Project Name: Land off Park Street

Project Number: 25006

This addendum has been prepared to supplement the site specific Flood Risk Assessment (FRA) [document 25006-SVC-R-001] prepared by Stour Valley Civils Ltd. The latest version of the FRA (revision B) should be read in conjunction with this addendum.

Wiltshire County Council Drainage Team Comments

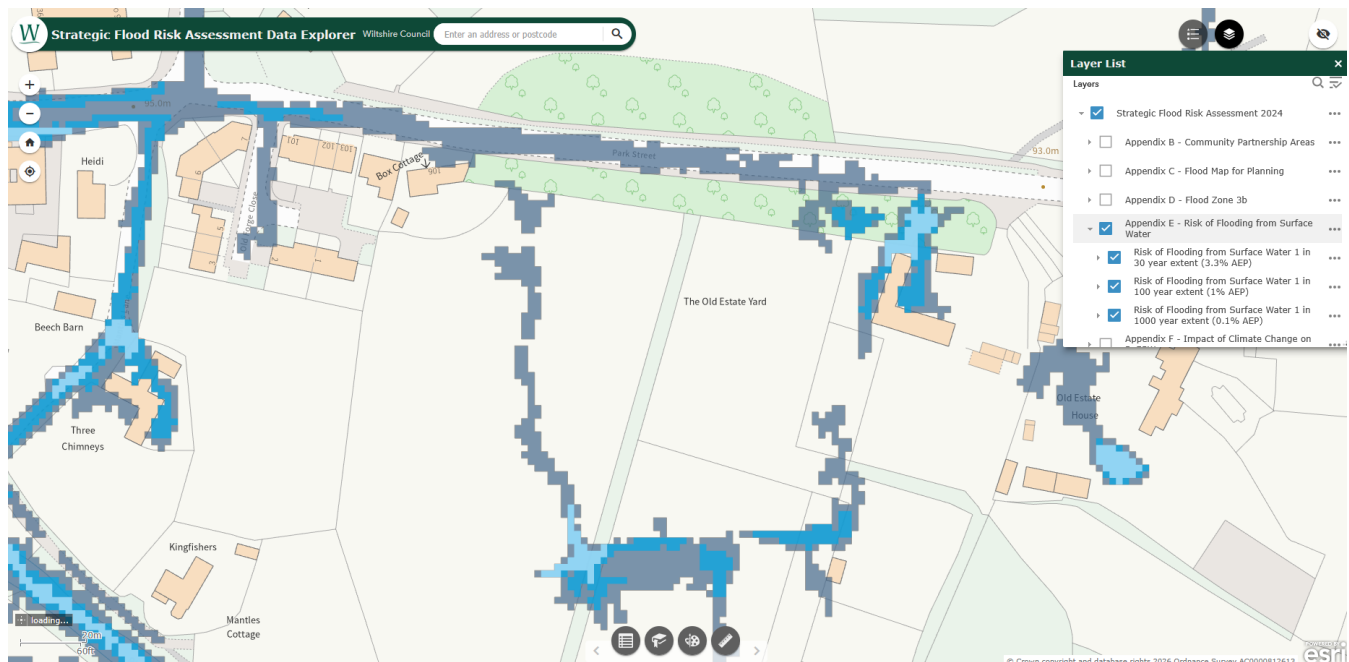
- Evidence that the finished floor levels are at a minimum of 150mm above surrounding ground levels*
- Details of the (foul) package treatment plants, including size, location, discharge arrangements and maintenance regime*
- The access to the site is predicted to flood, an emergency plan must be agreed with Wiltshire Council...*

As noted in the FRA, all finished floor levels will be set 150mm above adjacent ground levels. The Landscape plan has been updated to show proposed finished floor levels.

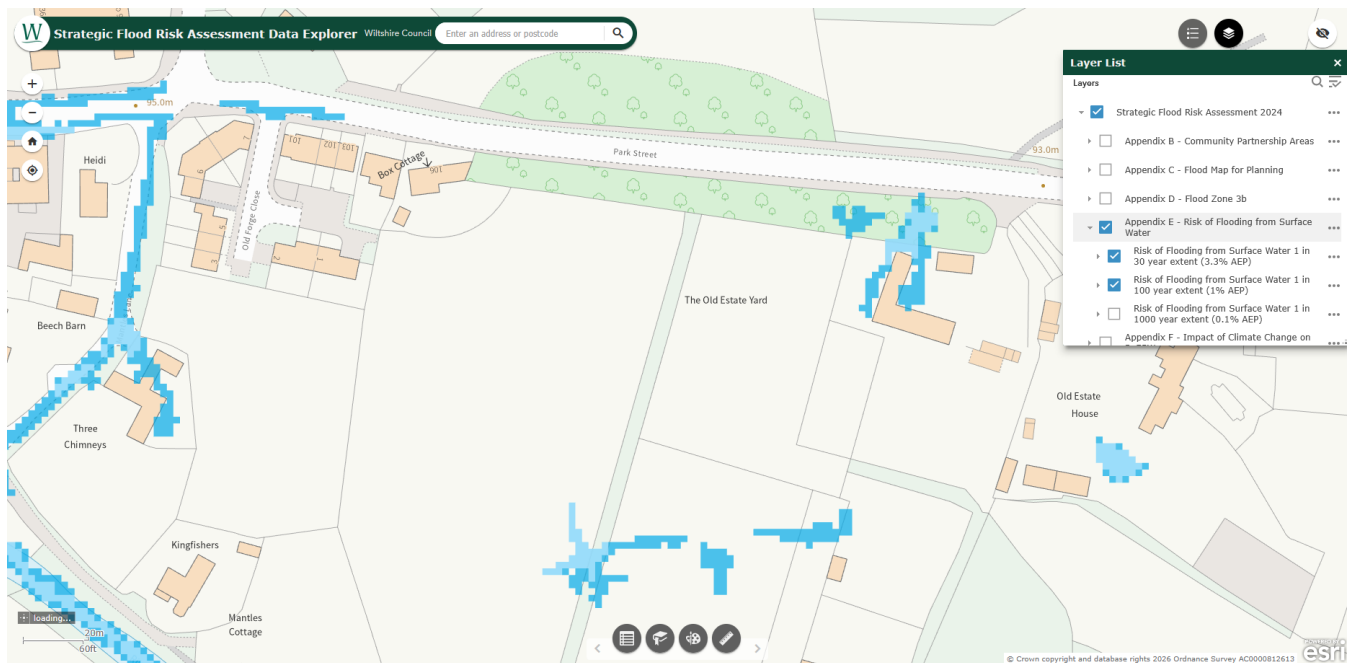
As noted in the drainage team response, the site access is shown to be at risk of surface water flooding during a 1 in 1,000 year event on the Wiltshire County Council SFRA mapping tool. For this event, the flooding appears to be confined to the carriageway of the road and does not affect the adjacent footways. On this basis, safe and dry pedestrian access would be available at all times and floodwaters on the road would not exceed kerb height (around 125mm), meaning any floodwaters would not pose a significant risk to emergency vehicles.

Regardless of which set of maps is deemed most current, both demonstrate that the access is not at risk of flooding for the design 1 in 100 year event, with the SFRA only showing minor flood risk during a 1 in 1,000 year event. On this basis, a Flood Warning and Evacuation plan, if required, is achievable for the development proposals and remains a safe, practical way to manage any residual flood risk.
